RE: 2014Re-mining Scofield Waste, Canyon Fuel Company, LLC, Skyline Mine, C/007/005

Title: 2014 Waste Rock Remining

Modified Plates 3.2.8-1 and 3.2.8-2 to include topsoil and subsoil storage areas

WASTE ROCK FACILITIES

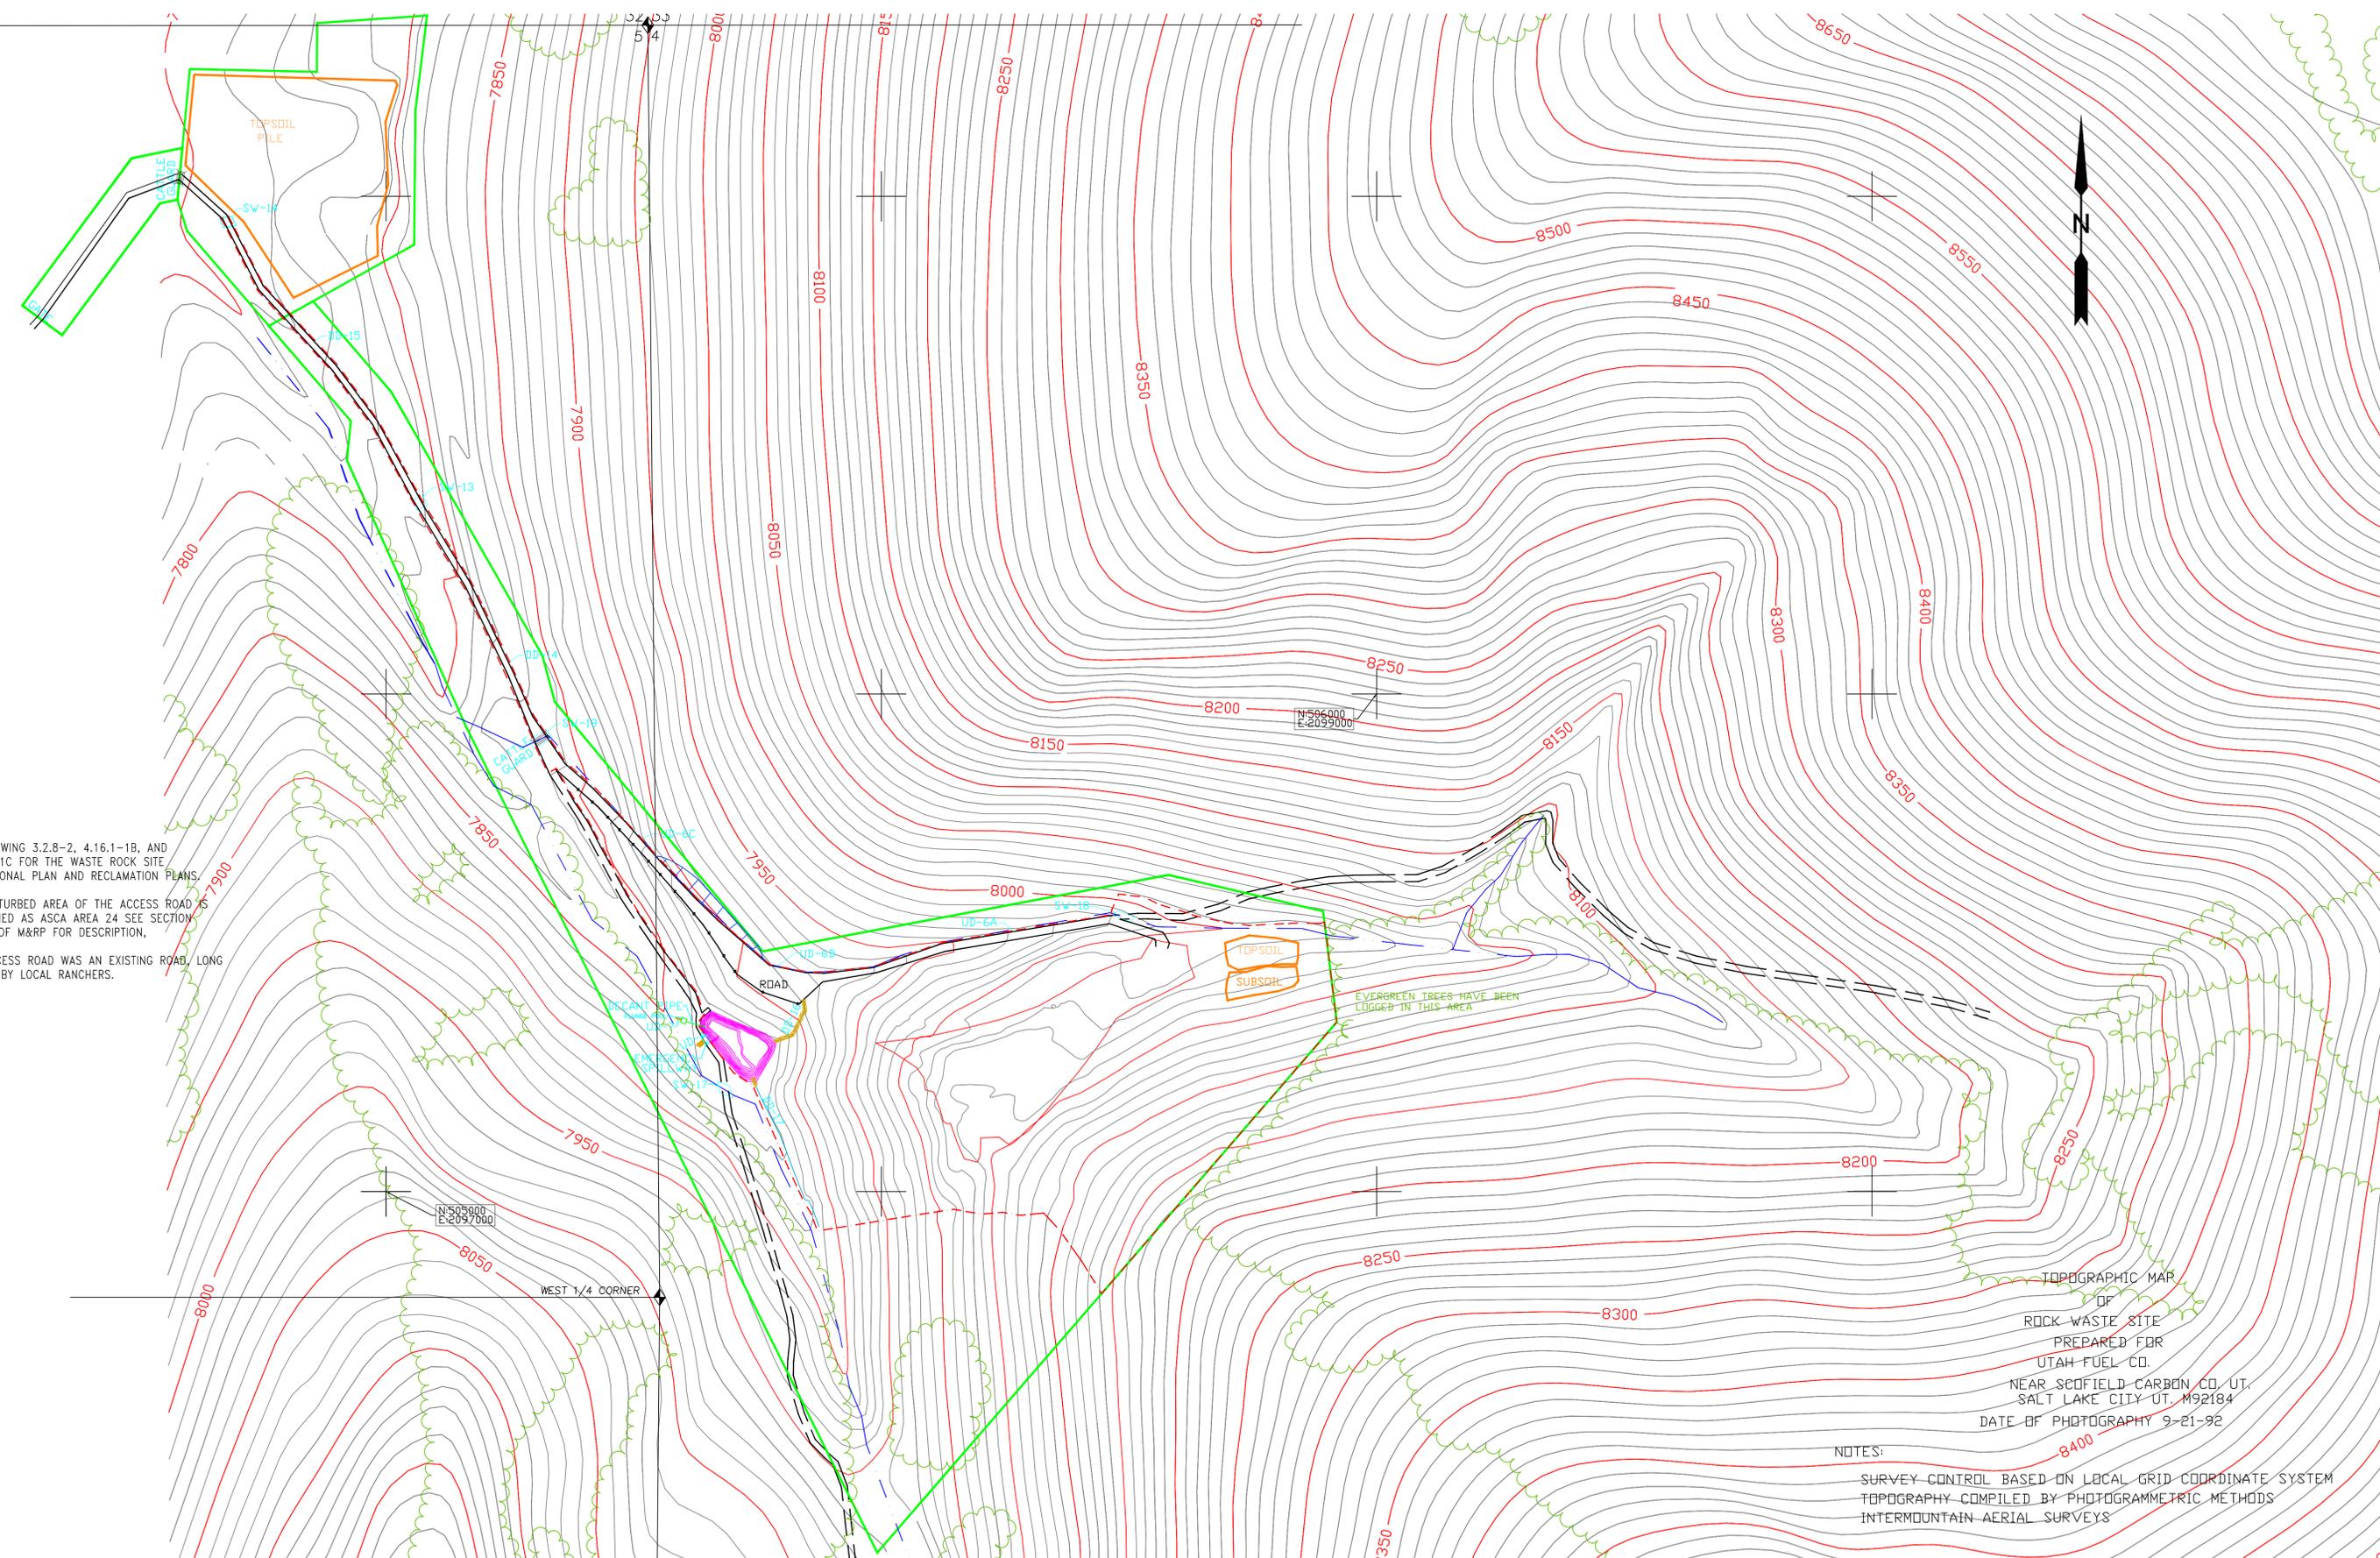
Attached to this letter are two (2) clean copies of modifications to Plate 3.2.8-1 – Waste Rock Facilities, and Plate 3.2.8-2 – Waste Rock Facilities and Drainage Control. Text modifications were also added to Section 3.2 – Components of Operation, and Section 4.6 Topsoil/Subsoil Handling plan outlining the activity. The modifications include modifications to the topsoil storage area(s), and addresses the handling of future removal and storage of topsoil previously placed during contemporaneous reclamation activities. The modifications were necessary due to both previous (2008) and currently proposed re-mining of the Waste Rock site. Activities that were conducted in 2008 included the combining of two (2) topsoil piles and the establishment of a subsoil pile which are illustrated on Plate 3.2.8-2. On Plate 3.2.8-1, a topsoil pile has been added to a pre-SMCRA disturbed area located near the entrance of the Waste Rock facility. In addition, the maps were modified to identify the existing topsoil and subsoil piles on top of the existing pile. The area adjacent to the Scofield cemetery was approved for mining activities in 2008 in a modification titled 'Waste Rock Pile Expansion' Task ID 2890. Scofield City was contacted concerning the proposed topsoil storage area and were not opposed to the activity.

DATE	No.	REVISIONS	APP'D	DES'D	DR.
7-89	1	ADD AREA 24-A			
9-20-89	2	DITCH NUMBER'S CHANGED			
9-29-89	3	NOTE ADDED			
7-1-92	4	REVISED FOR PIT EXPANSION			
5-19-94	5	ADD AREA 24-A			
5-02-07	6	ADDED EXPANDED PERMIT AND DISTURBED AREA, AS-BUILT SEDIMENT POND, AND UNIMPROVED ROAD		G.C./G.R.	
5-15-14	7	ADDED Topsoil/Subsoil Piles, Removed "Access Road" from title block		G.C./G.C.

WASTE ROCK FACILITIES AND DRAINAGE CONTROL

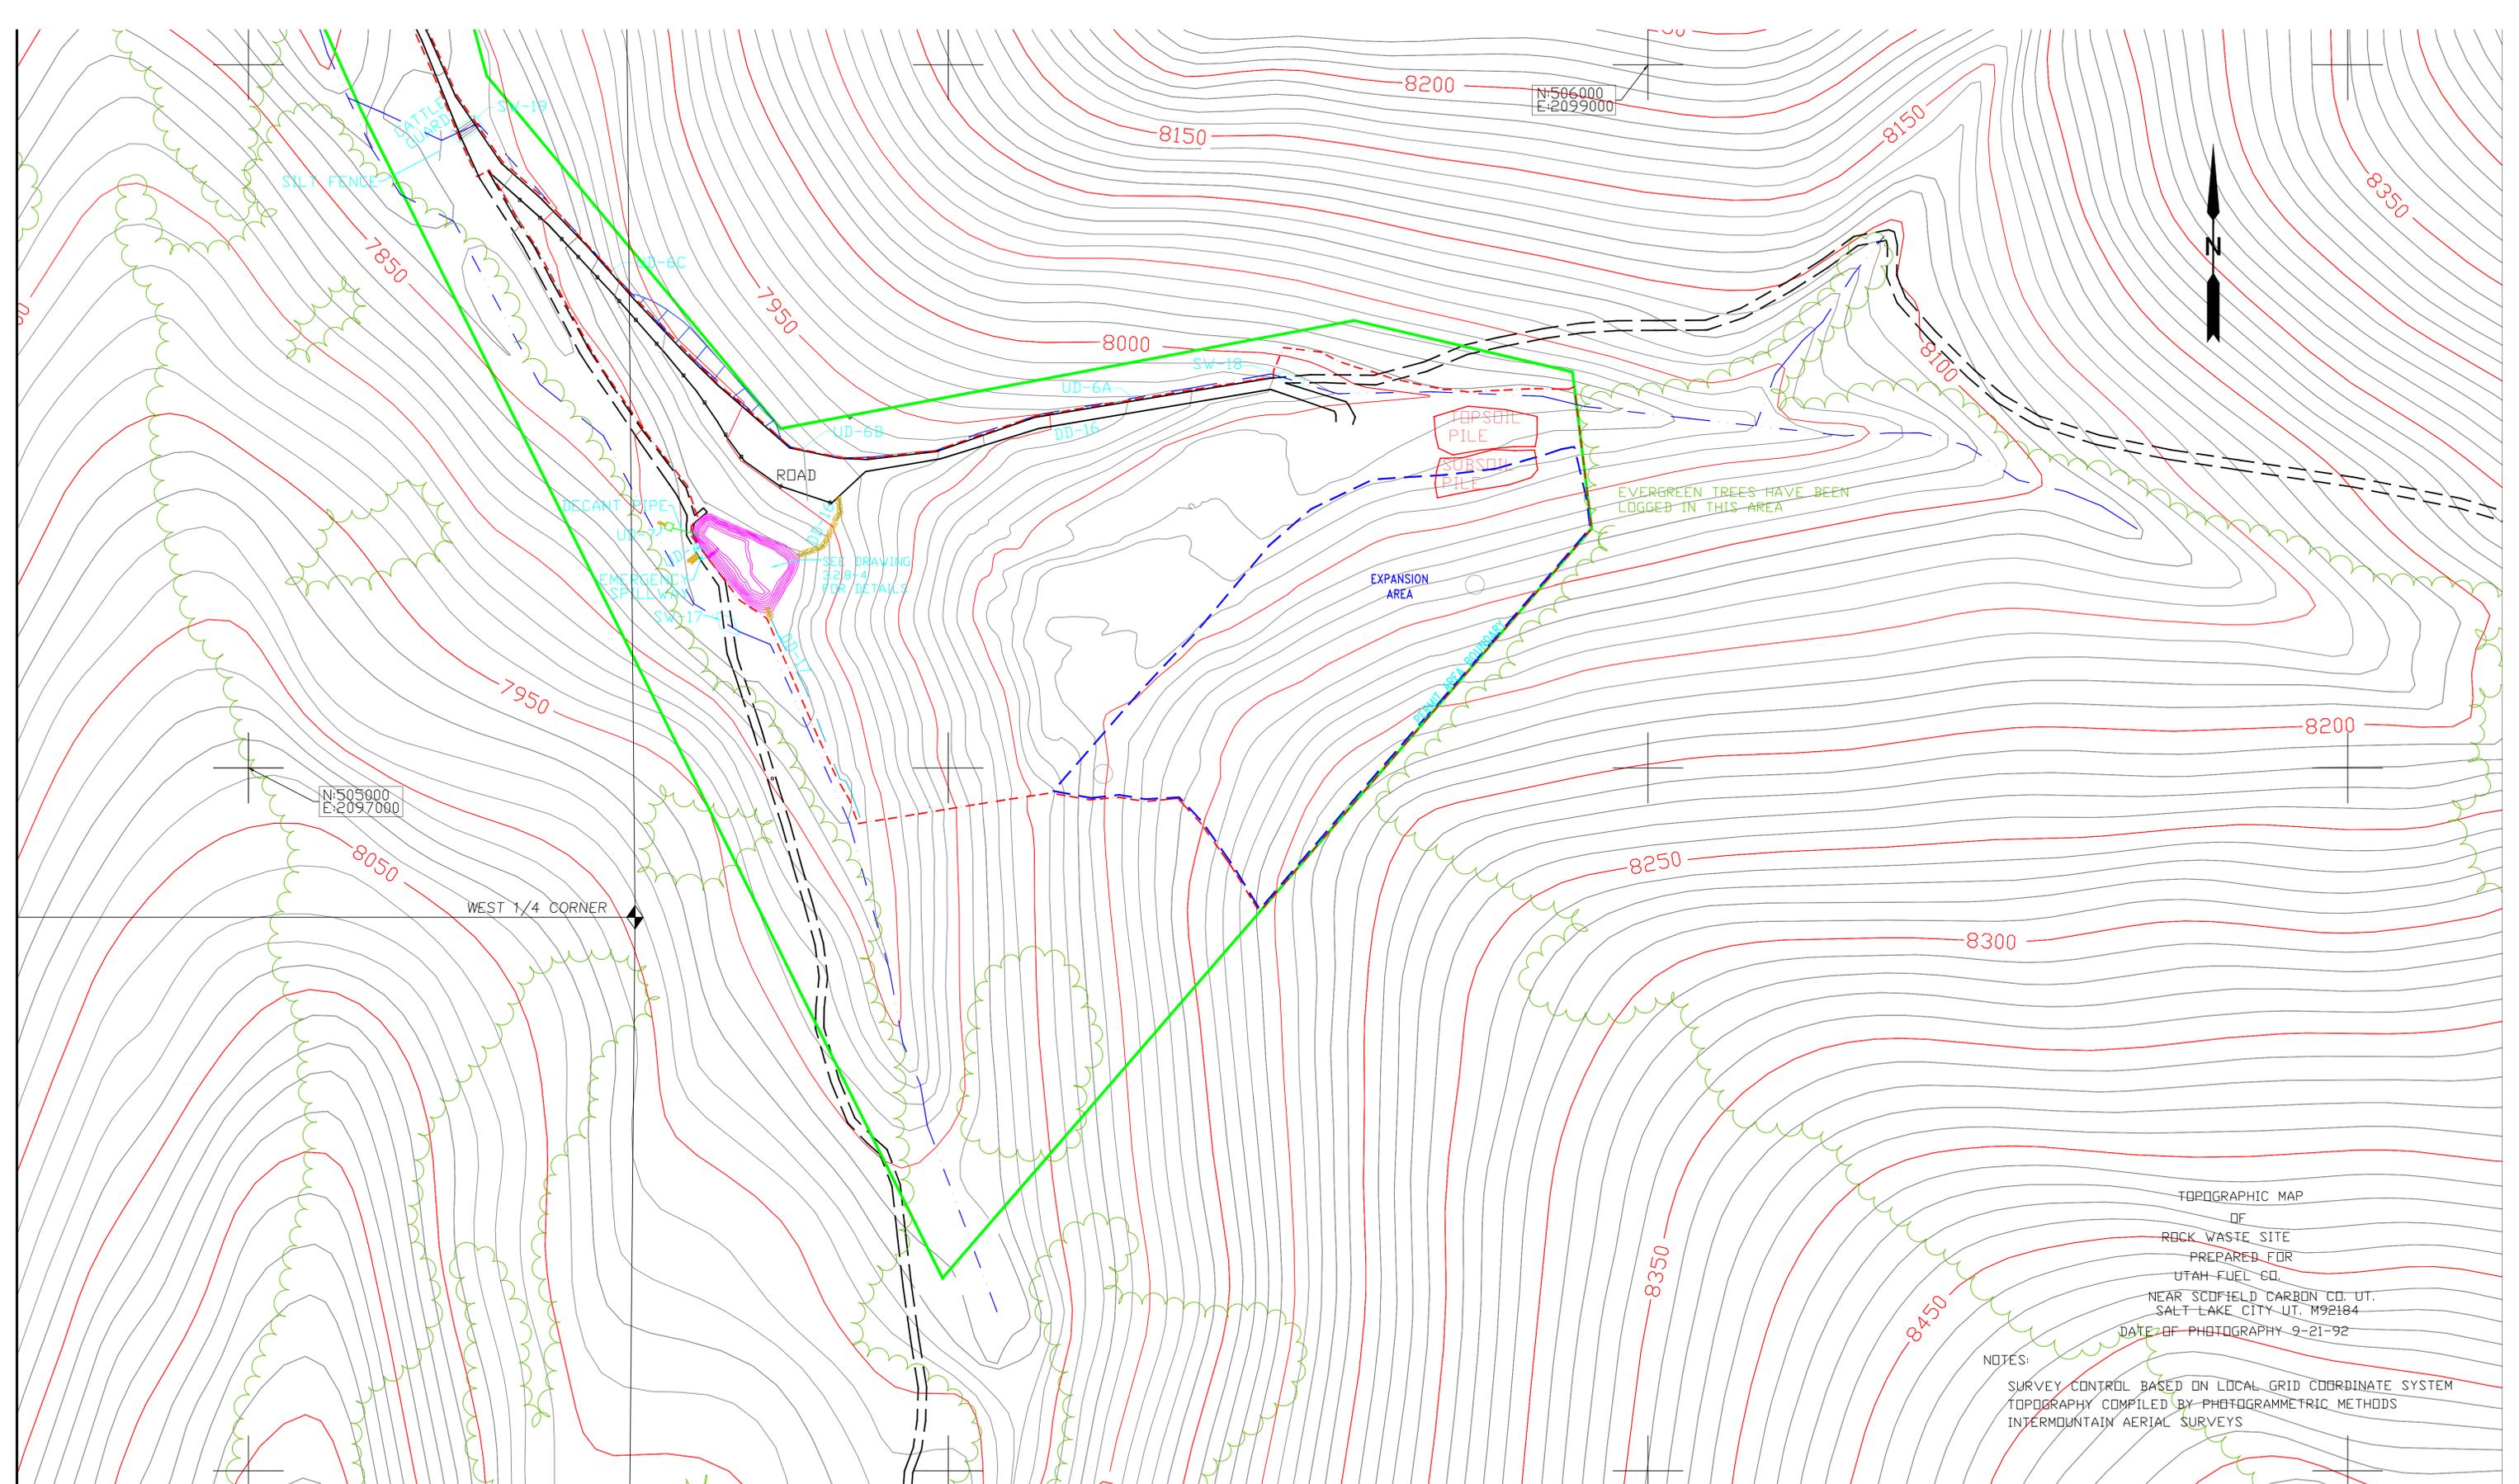
DATE	No.	REVISIONS	APP'D	CHK'D	DR.
09-1-98	1	SHOW EXPANDED AREA			G.T./J.F.
11-10-98	2	ADDED TOP SOIL STOCKPILE			G.T./J.F.
01-11-98	3	SHOW ALL OF PERMIT AREA BOUNDARY			G.T./J.F.
04-16-99	4	TEMPORARY DRAINAGE DIVERSION			G.T./J.F.
10-12-05	5	REMOVED SILT FENCE ALONG ACCESS ROAD			G.G./J.T.
02-01-06	6	REMOVE ROAD LINES, FIX TITLE BLOCK			G.G./J.T.
05-02-07	7	ADDED EXPANDED PERMIT, DISTURBED, AND PILE EXPANSION AREA, AS-BUILT SEDIMENT POND, AND UNIMPROVED ROAD.			G.G./B.R.
05-09-08	8	ADDED TOPSOIL PILE, MODIFIED EXPANSION AREA LINE			G.G./G.G.
05-15-14	9	Relocated one topsoil pile, ADDED subsoil pile			G.G./G.G.
